WARRANTY INFORMATION SERVICE INFORMATION

Vapor Separator Cover (VST) Fitting

MERCURY

Pro Max 200/225 HP,
S/N 0G857653 Thru 0G858175

57753

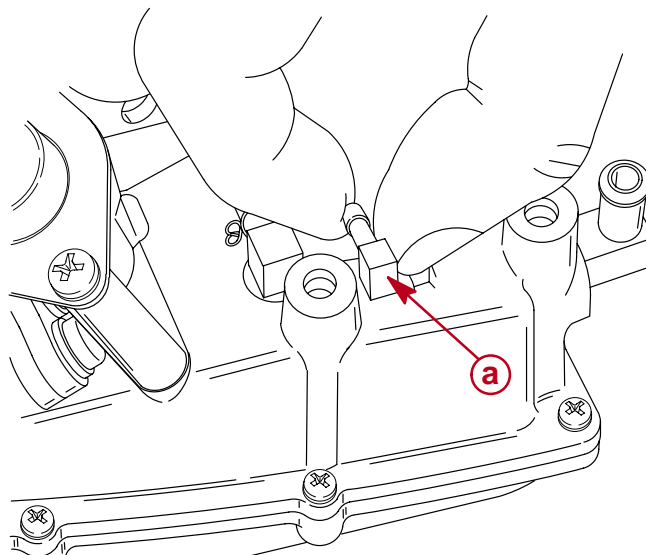
An inaccurate manufacturing process of the bleed return hose fitting on the top cover of the Vapor Separator Tank (VST) may cause the fitting to be loose. This is a pressed in elbow fitting that allows recirculated oil/fuel from the reed block area to enter the VST. The fitting should be checked for looseness and replaced if necessary.

If the outboard is within the above serial number range and does NOT have the factory rework markings on the engine carton or engine, check the fitting for tightness. Remove the bleed return hose from the fitting, and by hand using moderate pressure try to twist the fitting in the VST cover. If the fitting can be turned by hand, it should be replaced with fitting **P/N 22-877324**.

If the fitting can not be turned by hand, reinstall the bleed line, and mark a WHITE dot on the side of the VST.

57754

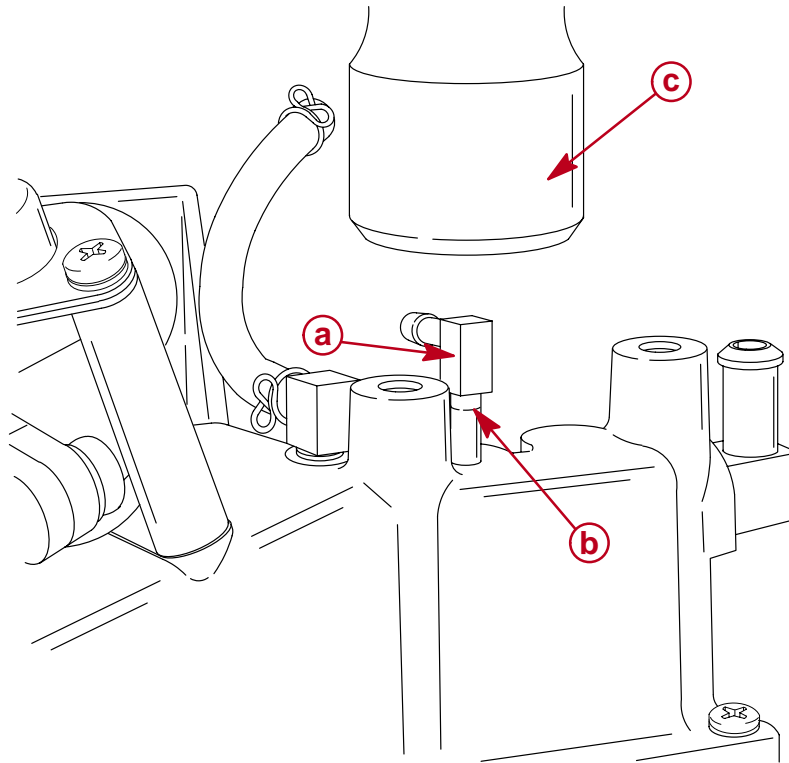
If the fitting is found to be loose, remove the old fitting. Install new fitting **P/N 22-877324** by carefully using a hammer to drive it into the VST cover. The fitting should be installed with the serrated portion facing down toward the cover. Check the new fitting for tightness, reinstall the bleed line, and mark a WHITE dot on the side of the VST.
